PUBLIC UTILITIES COMMISSION

Re: Data Request #2 for the SCE TLRR Gorman-Kern River 66 kV Project (A.22-02-014)

Document Title: Proponent's Environmental Assessment for Southern California Edison Company's TLRR Gorman-Kern River 66 kV Project

Description: Data Request #2

Figure 1: Gorman Sub Yard

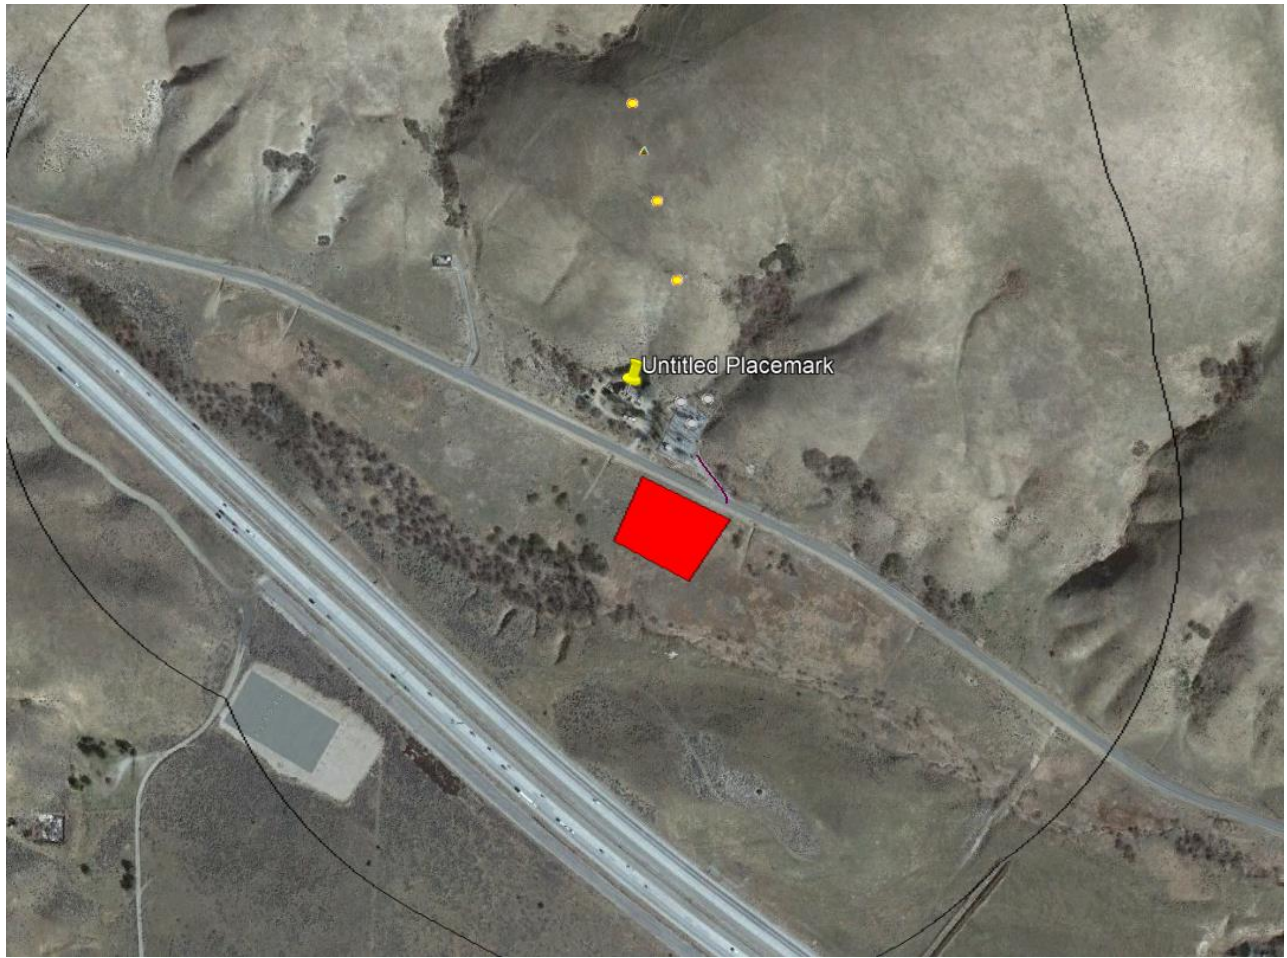
PEA Section or Page #	Comment Code	Data Request
Section 5: Environmental Analysis		
5.3 Air Quality Resources		
Section 5.3.1.2, Sensitive Receptor Locations, Figure set 5.13-1; Section 5.13, Noise of PEA	DR2-1	<p>The Project's Section 5.3.1.2 Sensitive Receptor Locations in Section 5.3 Air Quality Resources, and Table 5.13-3 Construction Noise Levels in Section 5.13 Noise Resources of the PEA states that there are no sensitive receptors near staging areas which have an approximate duration of use of 180 days.</p> <p>If a sensitive receptor is within ¼ miles of the project site but project construction in that vicinity would occur for less than 20 days, no health risk assessment would be required. However, if a sensitive receptor is within ¼ miles of the project site and project construction in that vicinity would occur for more than 20 days (such as a staging area), a health risk assessment should be conducted.</p> <p>On August 18, 2021, we provided a comment about the lack of a health risk assessment in the PEA. "...Based on construction activity duration, location of sensitive receptors relative to the construction activities, the document should state why a health risk assessment was not required."</p> <p>SCE responded on February 29, 2022: "As stated in Section 5.3.4.4 of the PEA, a Health Risk Assessment was not conducted because the GKR Project does not include the operation of new stationary sources that would result in the emissions of toxic air pollutants. Although the total duration of the construction activities could last for 24 months, it is unlikely the activities within the vicinity of the sensitive receptors will occur for more than the 2 months that the OEHHA guidance notes is the minimum time to evaluate cancer risks. Section 3.6.5 Work Schedule, describes the duration of the various activities that generally range from 1 to 20 days. For staging areas that could have a duration of 6 to 24 months, the location of these areas will not be within 1/4 mile of sensitive receptors."</p> <p>In our desktop analysis of sensitive receptors within ¼ mile from any project construction component, we found that the following staging areas had several residences within 1/4 mile. See list below and the attached screen shots from our desk top analysis.</p>

PEA Section or Page #	Comment Code	Data Request
		Data request: Please provide a list of the proposed staging areas and the duration of use for each staging area and the types of activities which would occur during that duration. If it is determined that staging area activities would occur for more than 20 days and include activities which would generate air toxics at any of the locations identified below, please provide the appropriate health risk assessment.

Staging Area Name	Receptor Type within 1.4 mile	Screen Shot Reference
Gorman Sub	1 resident	Figure 1
Frazier Mountain Road	5 residents	Figure 2
Lebec-Clear Canyon Rd	6 residents	Figure 3
Lebec Rd	1 school (El Tejon School	Figure 4
I-5	11 residents, 1 school (El Tejon School)	Figure 5
Ranco Road	1 resident	Figure 6
Banducci Rd	3 residents	Figure 7
Bakersfield Tehachapi Hwy	1 resident	Figure 8
Bakersfield Tehachapi Hwy (additional yards with the same name but different locations)	1 resident	Figure 9
Kern Canyon Rd	2 residents	Figure 10
Kern Canyon Rd (additional yards with the same name but different locations)	1 resident	Figure 11
